SUBJECT: **NEW VEHICLE DEMONSTRATION / DELIVERY HOLD - Safety Recall 19S23 - Supplement #1**
 Certain 2019 Model Year Ranger Super-Cab Vehicles
 Right Front Seatbelt Outboard Anchor

REF: **NEW VEHICLE DEMONSTRATION / DELIVERY HOLD - Safety Recall 19S23**
 Dated July 11, 2019

New! REASON FOR THIS SUPPLEMENT

FIGURE 2a

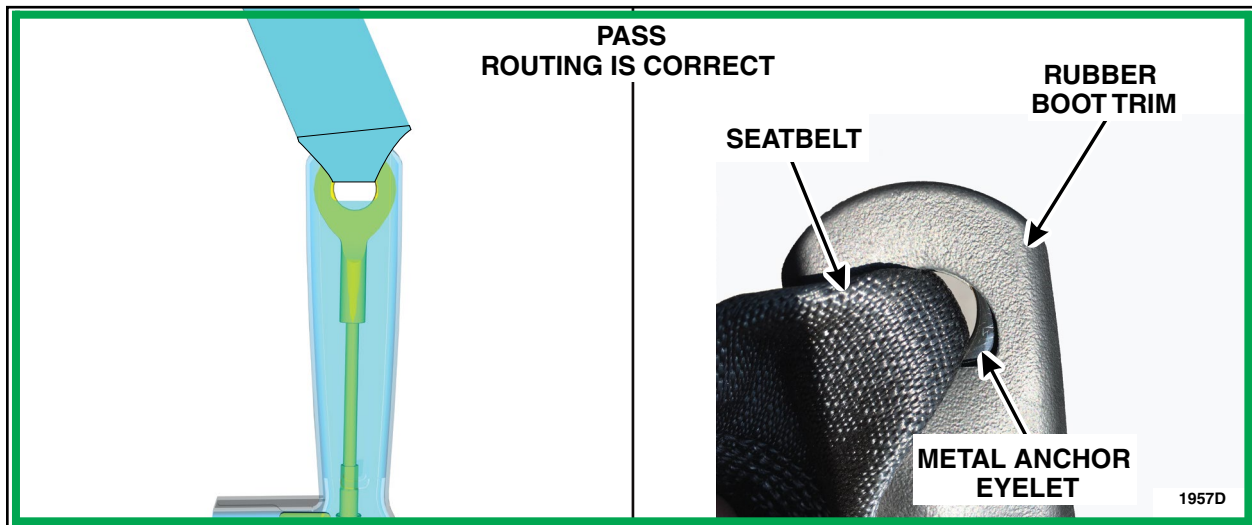
2. Visually inspect the right side front seatbelt routing through the metal anchor eyelet attachment.
See Figures 2a and 2b.

- Is the seatbelt routed through the rubber boot trim and through the metal anchor eyelet?
 - Yes – Inspection passes. No repair is required.
 - No – Replace the seatbelt retractor and pretensioner assembly. Please follow WSM procedures in Section 501-20A.
